BLUFFS AT CYPRESS CREEK SUBDIVISION, **PHASE TWO**

APPLICATION NUMBER 1 DATE August 16, 2018

APPLICANT Bluff's at Cypress Creek Subdivision, Phase Two

REQUEST Subdivision

DETAIL SITE PLAN

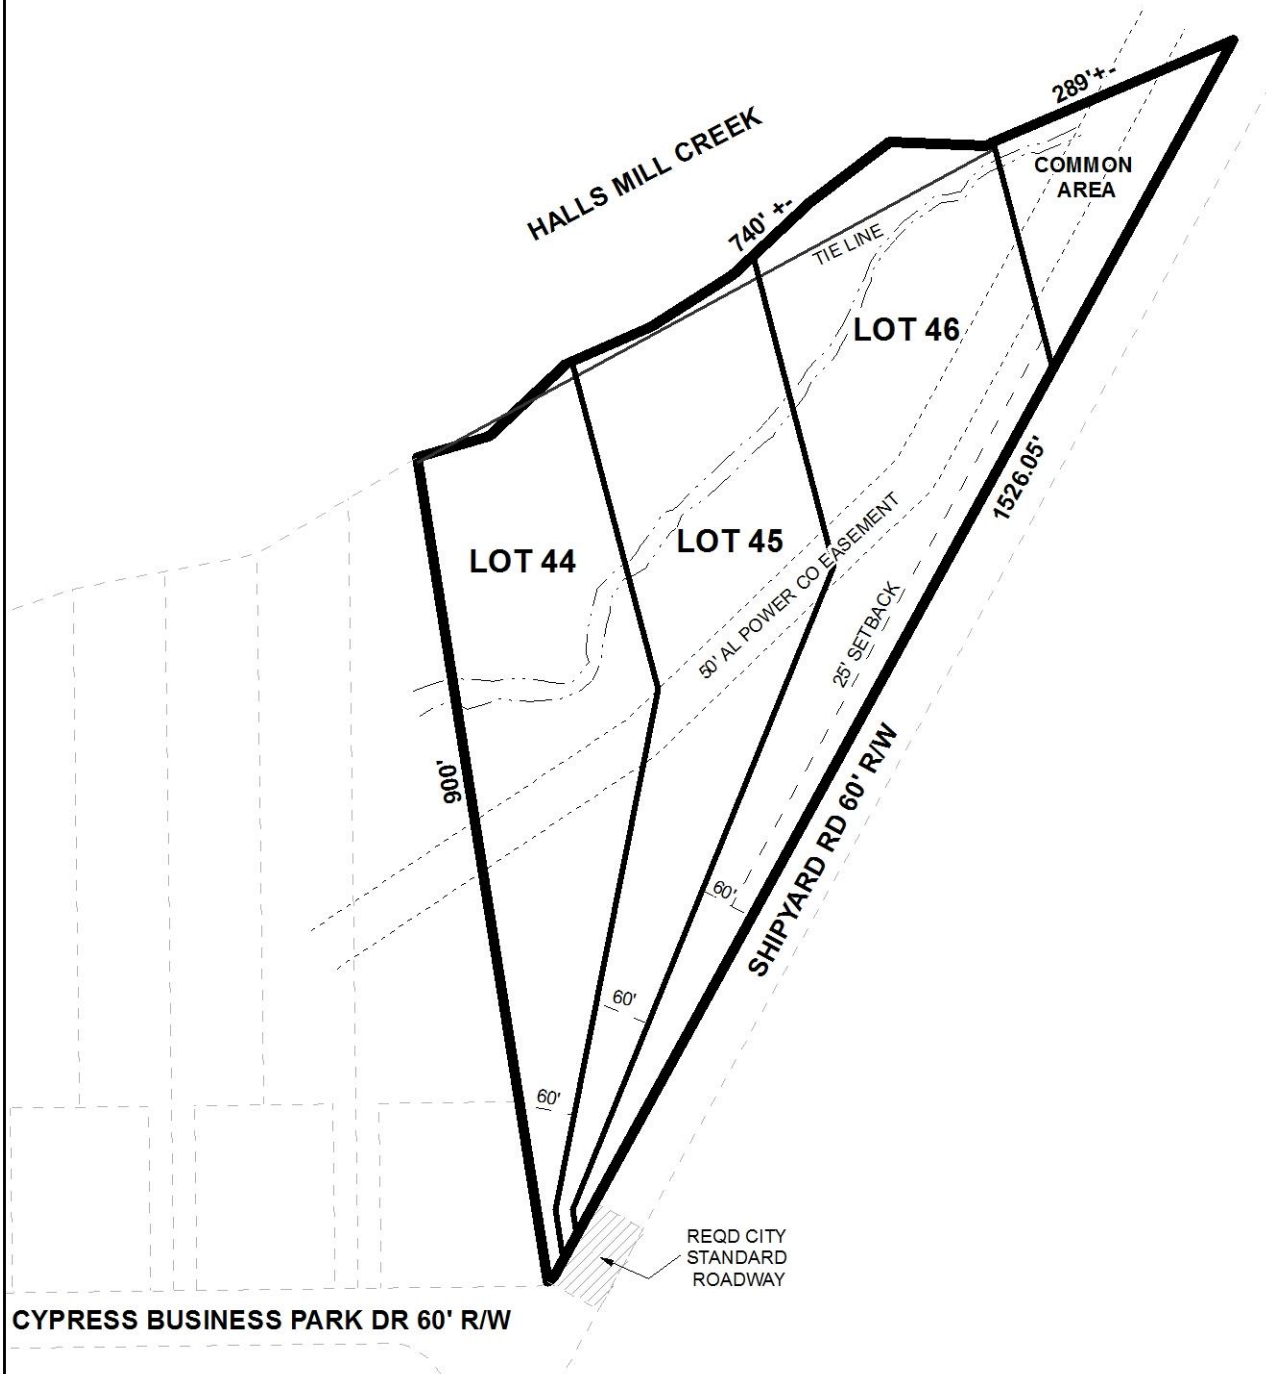
A revised plat was received by Staff and illustrates the requested revisions with the exception of labeling the 25' minimum building setback line where two (2) of the proposed lots are at least 60' in width. As such, if approved, revision of the plat to clearly label the 25' minimum building setback line where each lot is at least 60' wide should be required per Section V.D.9. of the Subdivision Regulations should be required.

It should be noted that the portion of the parent parcel that has been included in the Subdivision Request is labeled as "Common Area," but access to this area is limited through the proposed Lot 46.

- 1) revision of the plat to illustrate dedication sufficient to provide 30' from the centerline of Shipyard Road;*
- 2) retention of the lot sizes in square feet and acres on the Final Plat, or provision of a table on the Final Plat providing the same information;*

- 5) retention of dedication of the corner radius at the intersection of Cypress Business Park Drive and Shipyard Road;*
- 6) revision of the plat to clearly label the 25' minimum building setback line where each lot is at least 60' wide; and,*
